**Response to Peer Review Comments dated February 7, 2018**  
**Maine Medical Center, East Tower and Visitor Parking**

We are writing to provide supplemental information and respond to review comments presented in a memorandum From Wright Pierce Engineers dated February 7, 2018 regarding the above referenced applications.

Drawing Title  
**UTILITY PLAN**

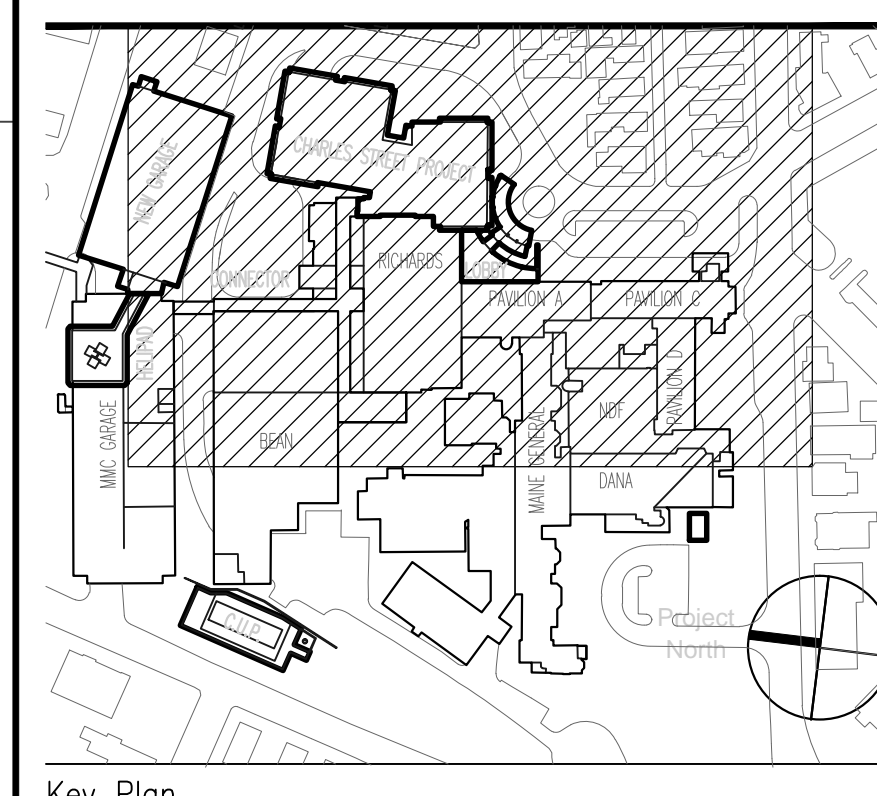
*ii) Plan 2D Boundary Survey indicates a connection or stub connection leading from the catch basin on the south side of the Visitor Garage that may allow for connection from the Visitor Garage roof drain into the separate storm drain system. The applicant shall provide the following:*

*(1) An updated boundary survey in the vicinity of "Plan 2D Boundary Survey" with utility elevations, pipe sizes, and pipe materials in accordance with the City's Chapter 14 and Technical Manual requirements for a Boundary Survey. Anecdotal information regarding the difficulty for construction in this corridor was discussed in the February 1 meeting. However, a sewer pipe crossing currently exists in this corridor, as does a storm drain or storm drain stub. City staff need additional information regarding existing utilities to confirm if a connection to the separate storm drain will be feasible or not.*

Each of these systems converge in the access road, in the vicinity of a drain manhole (identified as DMH# 22098 on the survey plan and is highlighted as DMH-112 on the design plans sheet C300) at the southwest corner of the parking garage. It is our understanding that it is this structure which the review comments refer to as a potential location for connection.

It is our opinion that making a drainage connection to DMH #22098 (DMH-112) or the catch basin CB# 22087 (CB-204) is not feasible due to interferences with other existing utilities and due to the potential risk associated with excavating behind the Visitor Garage earth retention system.

The staff comments note a drainage stub as a potential connection. We understand this to be a reference to the line shown projecting to the northeast from structure CB#22087 (CB-112). We

have investigated this opening in the manhole. This is not a drain stub that extends as far as the survey plan implies. This line represents the location of a temporary sewer pipe stub that was cored into the structure during the 2004-2007 construction as temporary means to convey a former sewer in this location to Gilman Street, while the Visitor Garage and the permanent sewer was under construction.

It appears that this opening is generally oriented toward the adjacent sewer manhole. The stub was cut and capped and sealed close to the structure after construction and prior to the installation of the adjacent sewer manhole, electrical manholes and duct banks. We believe that access to this entrance into the manhole is now obstructed by these other structures. Due to the tight clearances of the subsurface utilities in this area, excavations were backfilled with flow able concrete fill in this area.

EXCAVATION SUPPORT PLAN	
MAINE MEDICAL CENTER PARKING GARAGE	
Portland, Maine	
Date: 12/10/04	Job Number: 06-3634
Scale: 3/32"=1'-0"	Drawing No: SFC-2

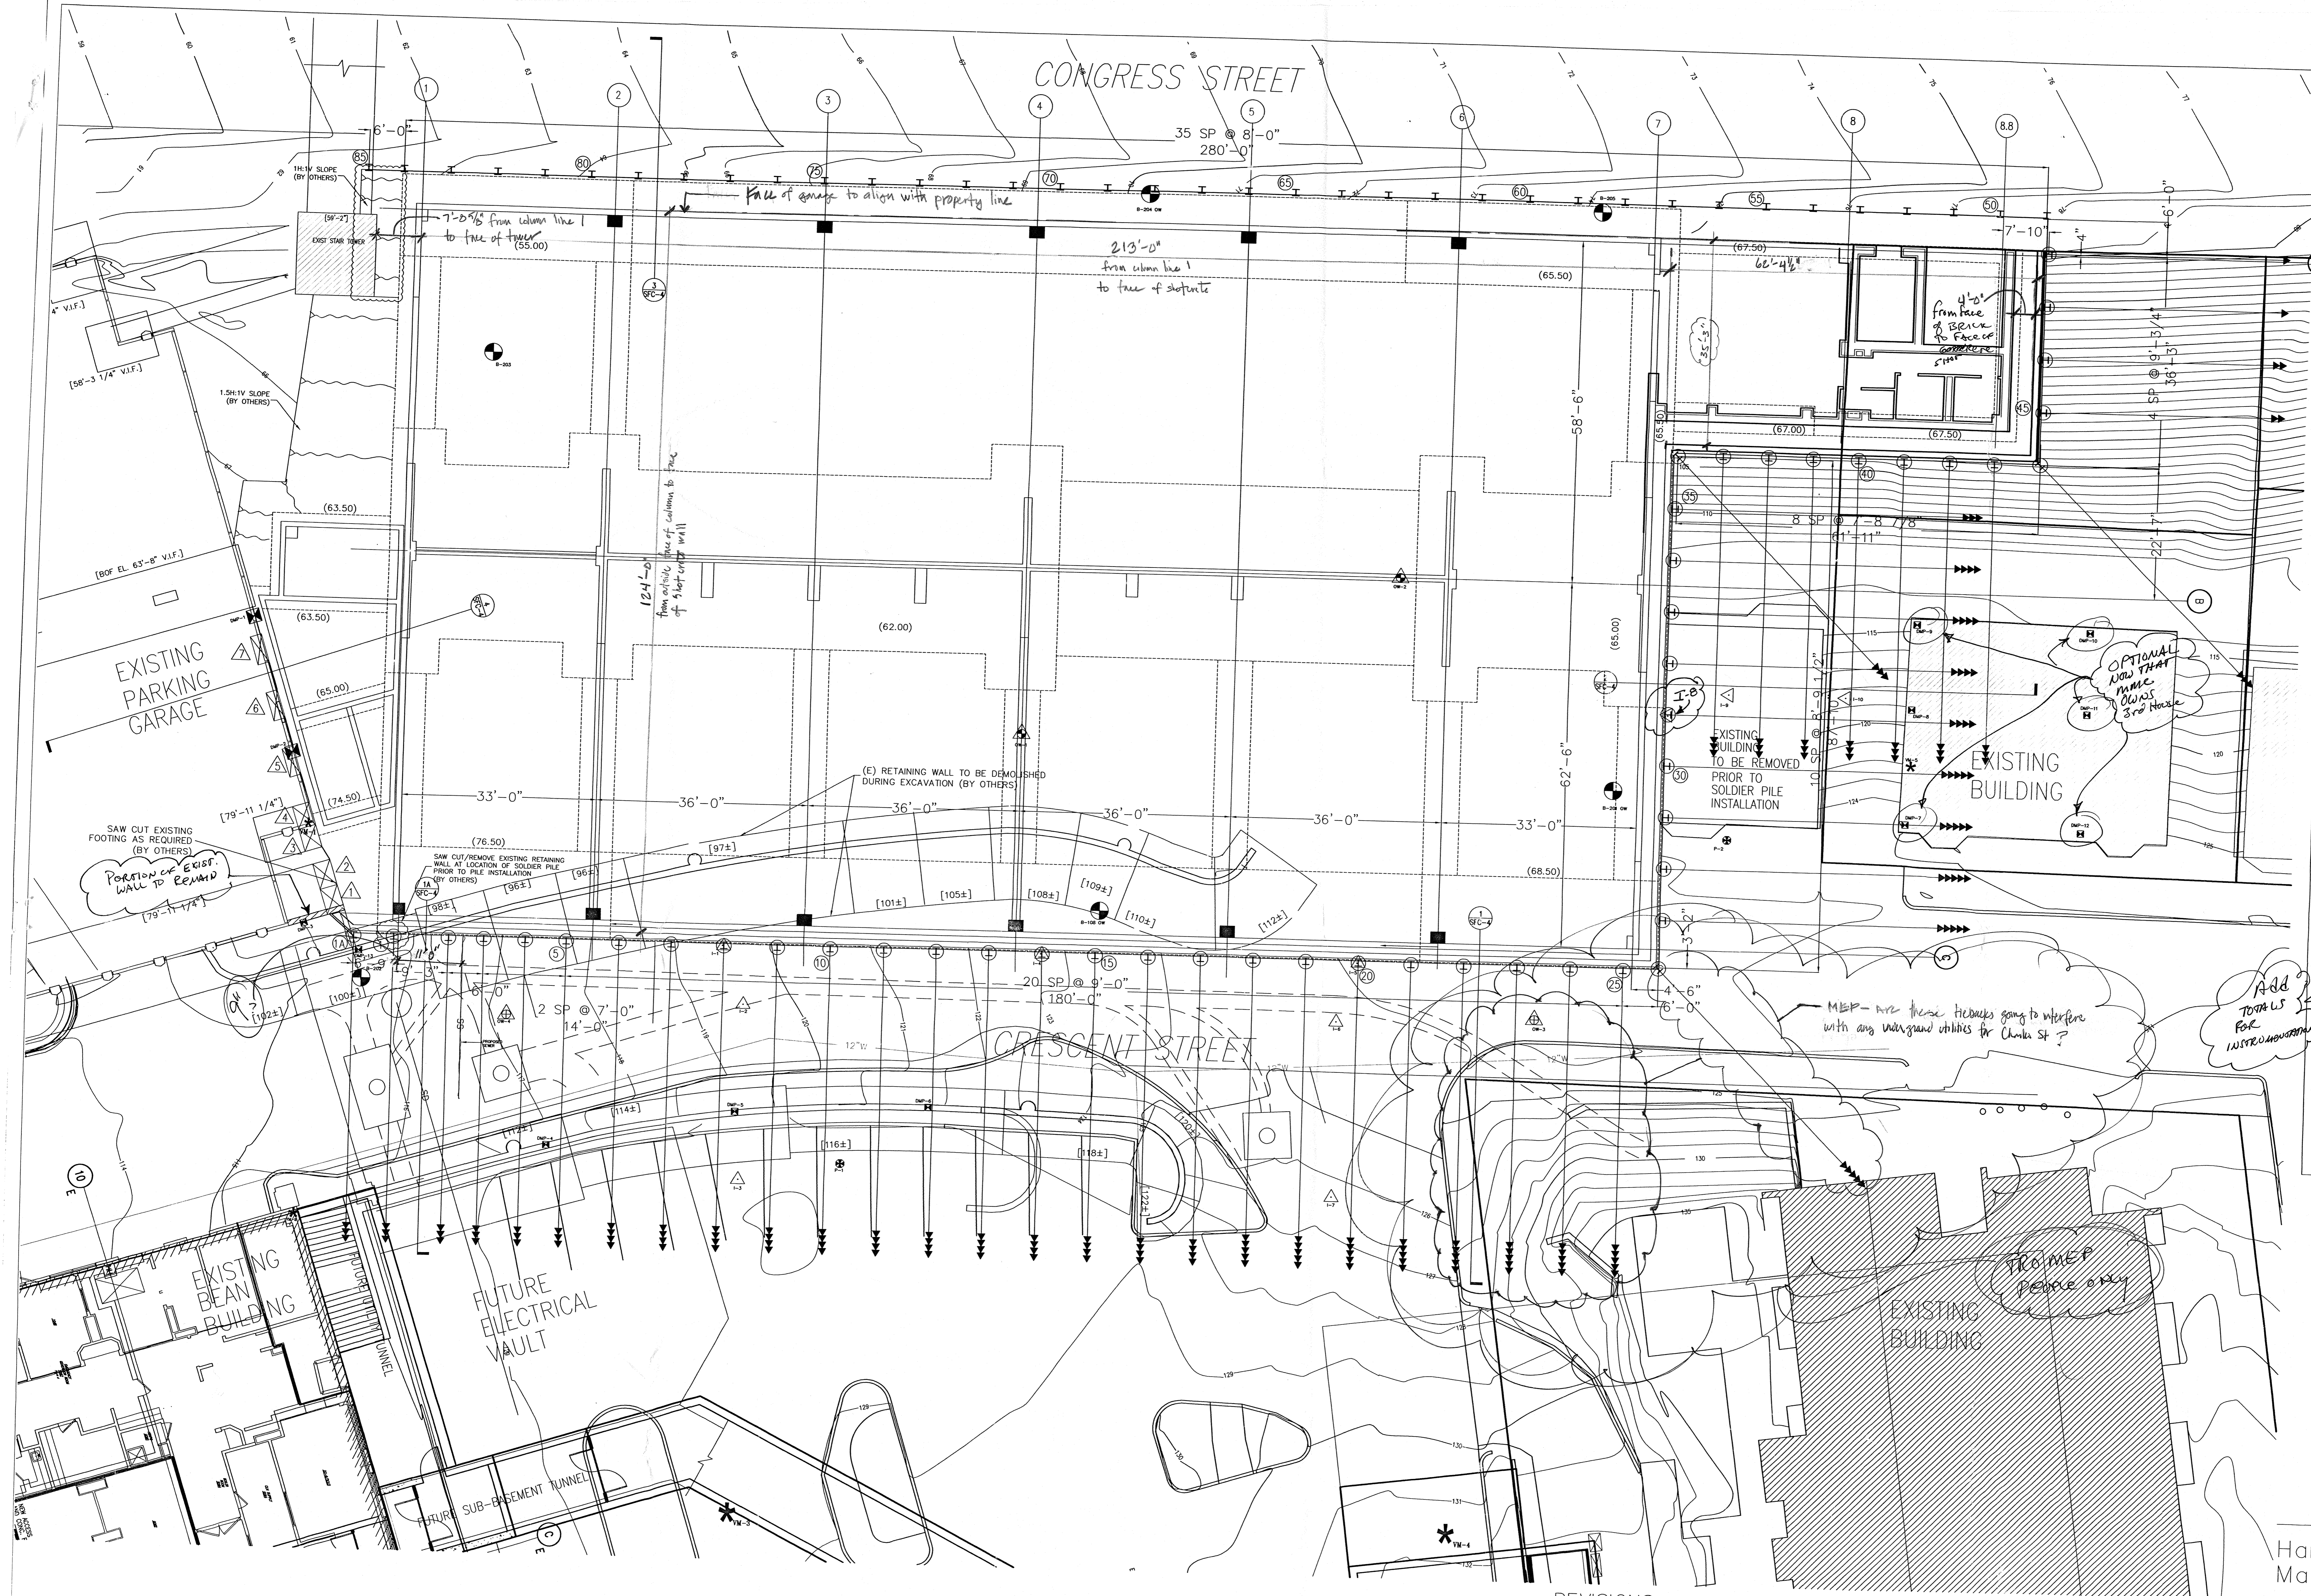
Attachment 3 also includes design plans for the Visitor Garage's earth retention system. The earth retention wall was constructed in 2004 to support a 40' to 60' vertical excavation for the construction of the garage. The retaining wall is a soldier pile and lagging wall with reinforced concrete facing backed with insulation and drainage board. The soldier piles are supported by post tensioned grouted tiebacks which extend 44 to 76 feet horizontally behind the wall. With the top row of tiebacks between 8' and 9' below grade. The area the Staff has suggested for a storm drain connection is highlighted on Sheets SCF-2, SCF-3 and detail 1A on Sheet SFC-4.

The staff comments correctly note that a sewer penetration of this wall does exist, as does a penetration for electrical conduit shown on the earth retention plans. These penetrations through the wall were carefully designed and coordinated with design-build contractor responsible for the design and installation of the retaining wall and tie backs and with the floor and spandrel locations of the garage.

The existing penetrations are reinforced to maintain the integrity of the wall and are spaced to avoid tie backs. We do not recommend cutting new penetrations through this wall. The wall was not designed with future penetrations in mind and have concerns regarding potential risk/liability associated modifying this wall or excavating in close proximity to the tie back tendons behind it.

It is also noted that all of the utility structures, duct banks and electrical manholes in the access road at this location were constructed prior to the installation of retaining wall tie backs and tendons. This was an intentional sequence of construction employed to mitigate risks associated with excavating in close proximity to the highly tensioned tie back tendons.
